#	Date	Issue / Description
01	05/02/16	1ST PLANNING SUBMITTAL
02	09/15/16	2ND PLANNING SUBMITTAL

# METRO CENTER

**ALAMEDA PARKWAY & SABLE BLVD.  
AURORA, CO 80012**

**WOODBURY CORPORATION**

PHASING PLAN  
PLANNING AREA 9

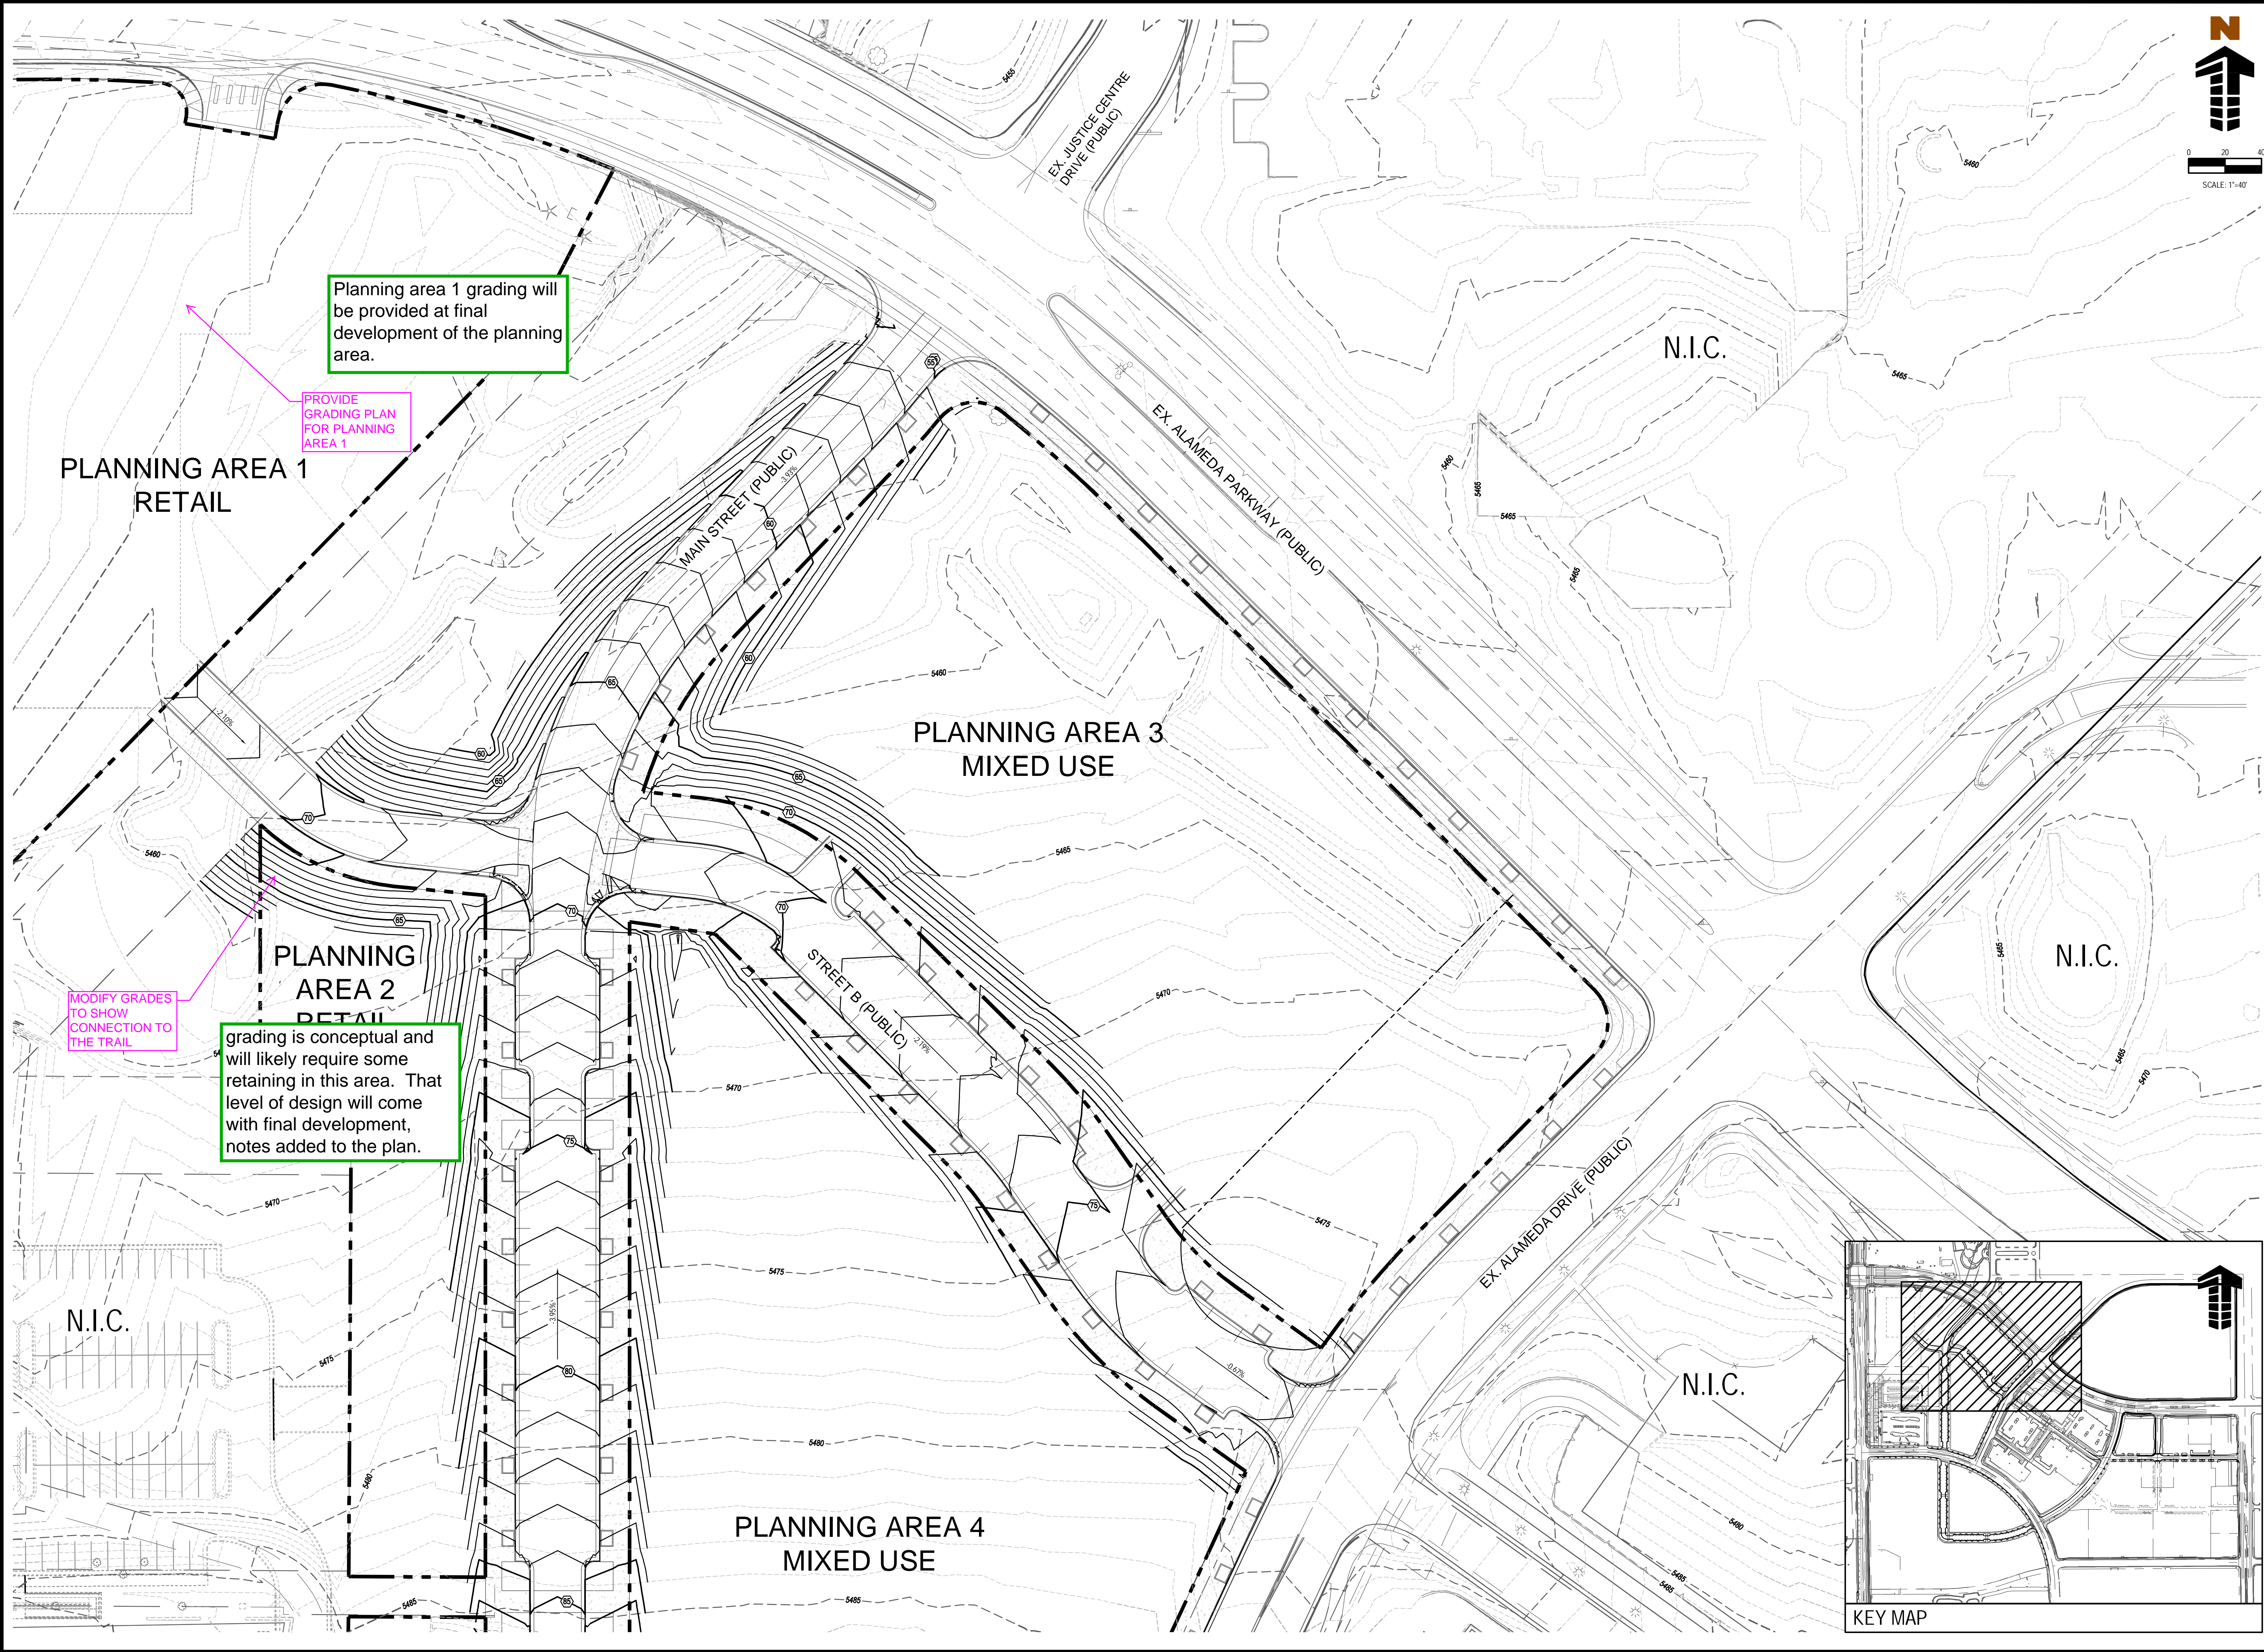
ADD  
"CONSTRUCT  
STREETSCAPE  
IMPROVEMENTS  
WITHIN EXISTING  
STREET RIGHTS-  
OF-WAYS"

Illustrate approved site plan in background

✓ Illustrate approved site plan in background
